City of Detroit
Inter-Departmental Communication

RE: Petition No. 572
Request Outright Vacation The North/South alley IN The Block Bound By
Charlotte, Park, Temple, And Cass

NOTICE OF PROPOSED CHANGE IN PROPERTY

B						<p align="center"> REQUEST TO OUTRIGHT VACATE THE NORTH/SOUTH PUBILC ALLEY, 15 FT.WD IN THE BLOCK BOUND BY CHARLOTTE AVE., PARK AVE., TEMPLE AVE. AND CASS AVE. </p>	CITY OF DETROIT CITY ENGINEERING DEPARTMENT SURVEY BUREAU	
A							JOB NO. 01-01	
DESCRIPTION		DRWN	CHKD	APPD	DATE			
REVISIONS								
DRAWN BY		CHECKED						
DATE		APPROVED						
							DRWG. NO. X 572

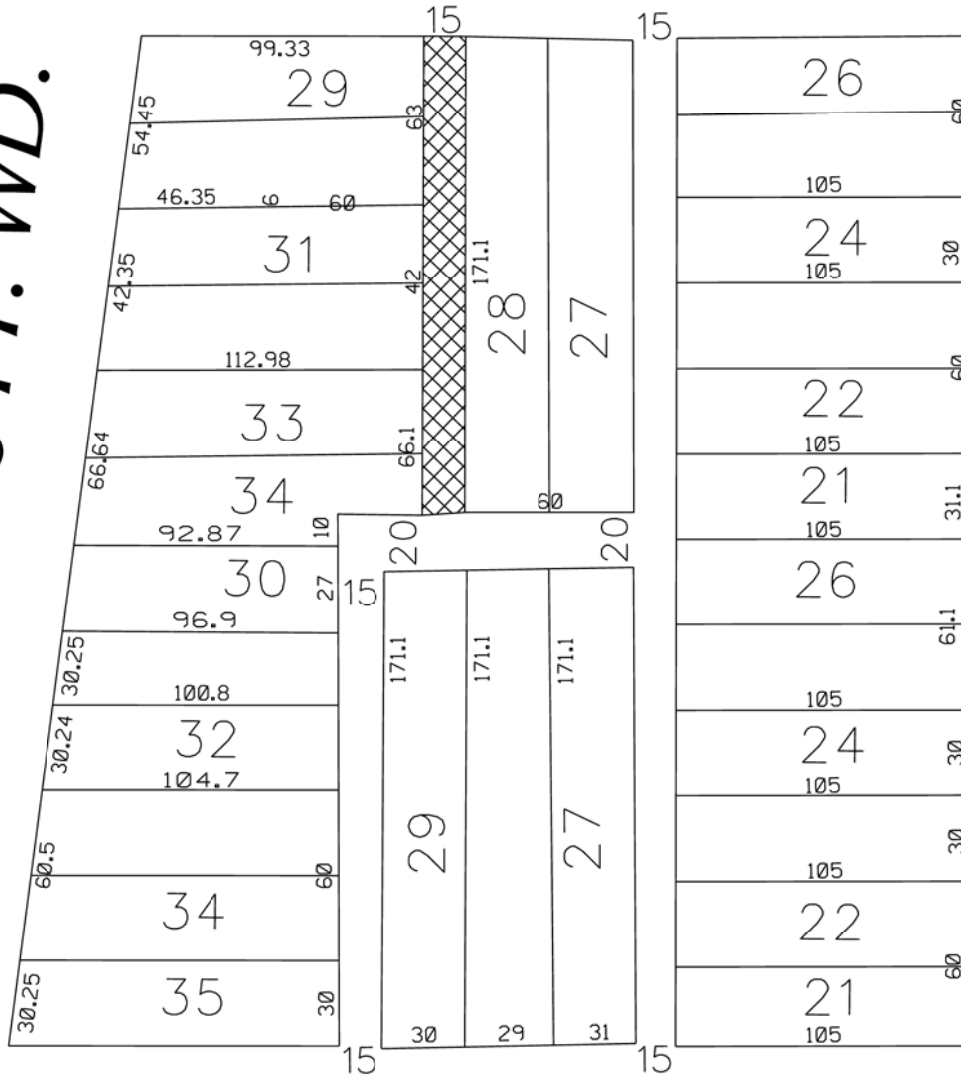
The Detroit Water and Sewerage Department (DWSD) is in receipt of the subject petition. There is a sewer located in the alley requested for vacation. DWSD has no objection to the requested vacation provided that the following conditions are met:

- The sewer services no other properties and only services the properties owned by the Petitioner, if not the Petitioner must prepare a relocation plan for the sewer signed by a Registered Engineer, DWSD approves the relocation plans, and the Petitioner grants a satisfactory easement for the relocated sewer. The Petitioner is to bear the entire cost of the proposed relocation plans, including construction, demolition, permitting, inspection, survey, etc.
- If DWSD is to maintain ownership of the existing sewer a satisfactory easement must be granted by the Petitioner.

Provided that the petitioner shall design and construct proposed sewers and to make the connections to the existing public sewers as required by the Detroit Water and Sewerage Department (DWSD) prior to construction of the proposed sewers,

Provided that the plans for the sewers shall be prepared by a registered engineer; and further

Provided that the petitioner shall grant to the City a satisfactory easement for the sewers; and further
